FTI-NSP2 Type 2 - Vehicle Coverage & Preparation Notes

FTI-NSP2 Harness Bulletin - Mis-wired POC1 (parking lights)

But wait! First check your harness...

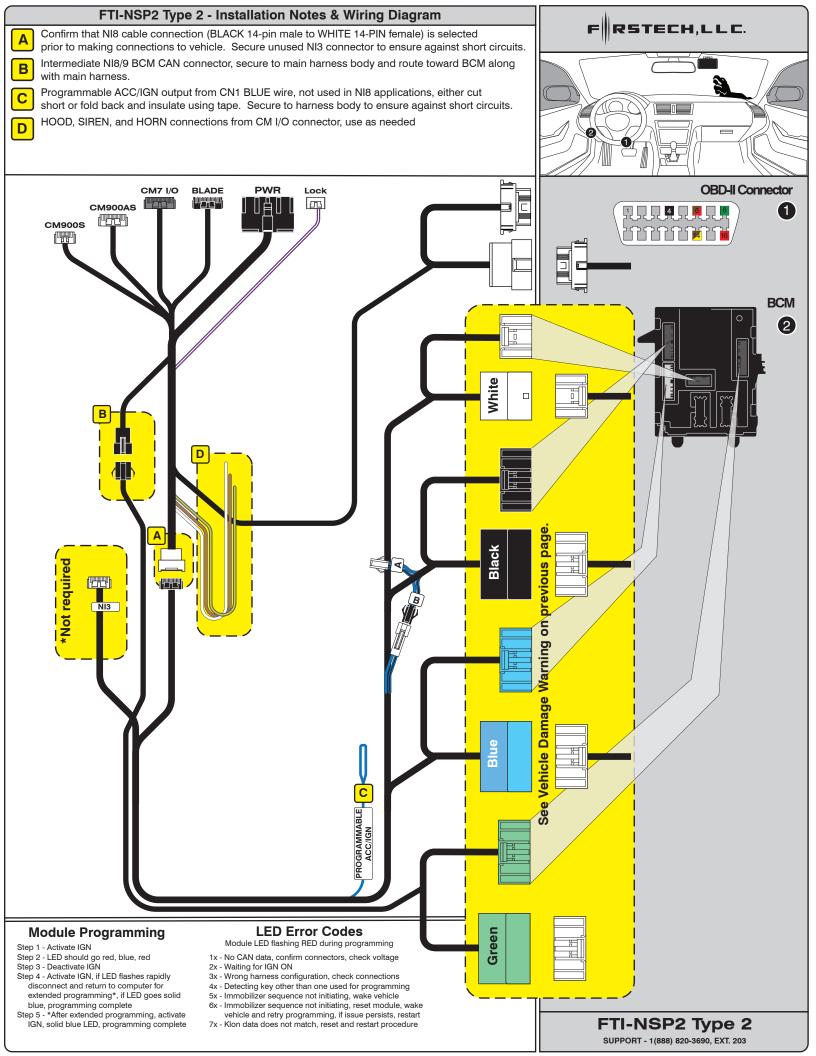
The initial production release of the FTI-NSP2 harness has an issue where the green/white POC1 circuit is incorrectlypositioned in the CM7 I/O connector. This issue affects only the gray 20-pin CM7 I/O connector illustrated on page 3 of this guide. Please confirm whether you are installing one of the affected harnesses by comparing the CM7 I/O connector to the illustration on page 3. If the green/white wire is as highlighted in Fig.1, proceed with the modification and follow the POC assignments listed on page 3.

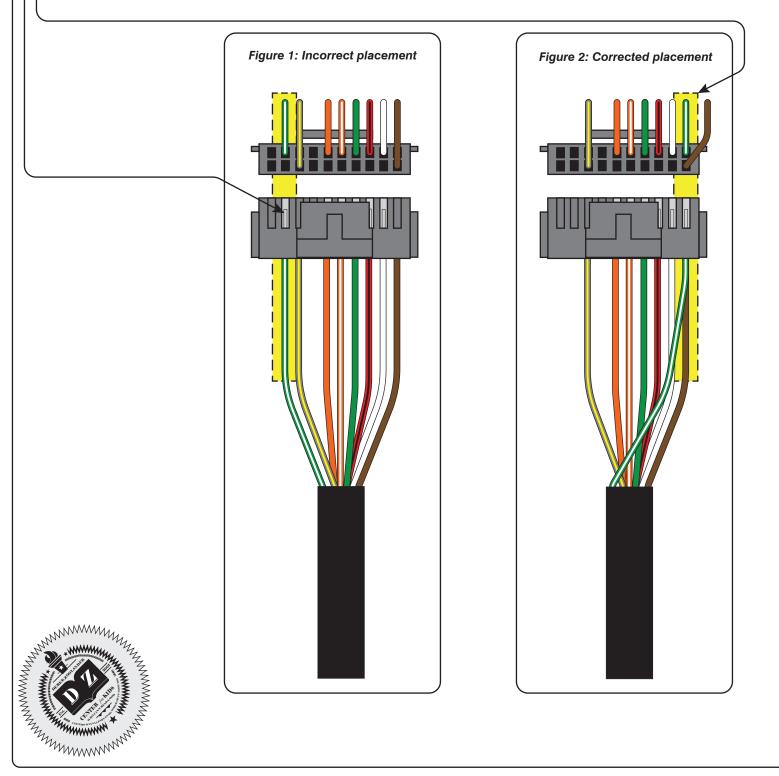
Overview: The initial production release of the FTI-NSP2 harness has an issue where the POC1 circuit is incorrectly positioned in the CM7 I/O connector. This issue affects only the gray 20-pin CM7 I/O connector illustrated below in figure 1.

Issue: The green/white parking light circuit is positioned in pin position #17, the fixed light output where the green/white wire is typically placed for parking lights, but the harness solution uses the vehicle hazard lights instead, the result when used as supplied is an erratic light display.

- 1.) Use a pick tool to depress the locking tab on the terminal connector of the green/white wire
- 2.) Remove wire and prepare to reposition
- 3.) Once removed, reposition the locking tab by using a razor knife to lift the tab into a usable position
- 4.) With locking tab repositioned, relocate to pin position #1 (top right position as illustrated)
- 5.) Push the terminal connector into the I/O connector housing until the locking tab clicks into place and the wire is secure
- 6.) Correction complete, you may now complete the installation, but remember to configure POC1 for Hazards (setting #30)
